AERO ACCESSORIES, INC. SERVICE BULLETIN

SERVICE BULLETIN: SB-008

SUBJECT: Rear Port Wear Indicator Instructions.

APPLICABILITY: AA215CC, AA215CC-9, AA216CW, AA3215CC, AA3215CC-9,

Recommended Rear WIP Vane Wear Inspection

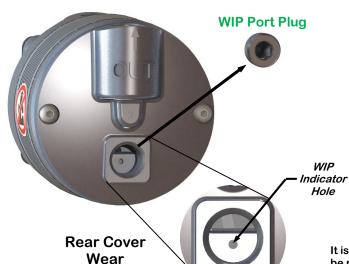
At 600 hours time in service remove the port plug and inspect pump vanes relative to the indicator hole. When inspection is complete replace the port plug and torque to 48 in./lbs.

If the inboard edge of the vane is not visible and the vane covers the entire indicator hole the next inspection should be performed at 1000 hours of pump service, and thereafter every 100 hours.

If the 600 hour inspection reveals the inside edge of the vane in the indicator hole, the next inspection should be at 800 hours of pump service, and thereafter every 100 hours.

If the 600 hour inspection reveals the inside edge of the vane at or below halfway of the indicator hole the next inspection should be at 700 hours of pump service, and thereafter every 100 hours.

It is recommended that the pump be replaced when the inboard edge of the vane is observed anywhere within the bottom 1/8th of the indicator hole.
